**Historical Architectural Review Board
COA Preliminary Review Sheet**

HDC-2026-00012

Address: 334 N. 9th Street

Proposal: Repair deteriorating brick facade

Front Elevation (Google Maps, April 2024)

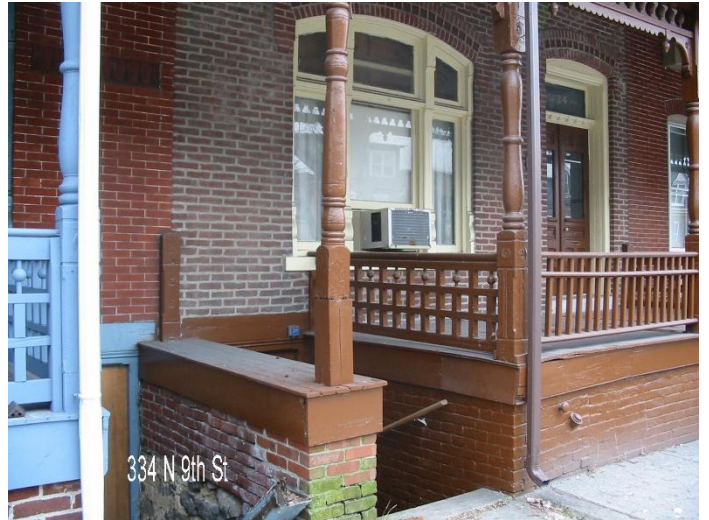
Observations & Comments: The proposed work is for the repair of the primary façade facing N. 9th street due to extensive water and structural damage related to improper mortar material. Stainless steel heli beam bars are proposed to be installed to provide structural support for the wall. Replacement brick units will match the existing in color and dimension and will be repointed with lime based mortar, which are appropriate treatments per the Guidelines. The existing front porch wall is currently painted brick; it is unclear if this area is included in the scope of work, and if the paint is intended to remain or be removed.

Discussion: The applicant clarified that the work area is on the 9th Street elevation above the porch roof; the first floor area under the roof and the brick porch foundation walls are not part of the scope of work. The applicant also noted that a previous repair had resulted in an area of stack bond, which was not the original bonding in that area, and that replacement brick would reestablish the original pattern. The HARB commended the applicant's approach to the work.

Staff Recommendation: Staff recommend approval with the following conditions:

- Brick bond matches existing configuration
- Product information for the helibeam system is submitted to staff for record, with notes about spacing/quantity of bars throughout wall.

Action: Mr. Knee moved to approve the application presented on 4/6/2026 for exterior brick repair at 334 N. 9th Street, and found compliance with Guidelines for Historic Districts: Chapter 3, Section 3.3 – Masonry and found no circumstances unique to the property, with the following conditions agreed to by the applicant: that the brick bond matches the original configuration, and that product information for the helibeam system is submitted to staff for record, with notes about spacing and quantity of bars throughout the wall. Mr. Huber seconded the motion, which carried with unanimous support and no abstentions.
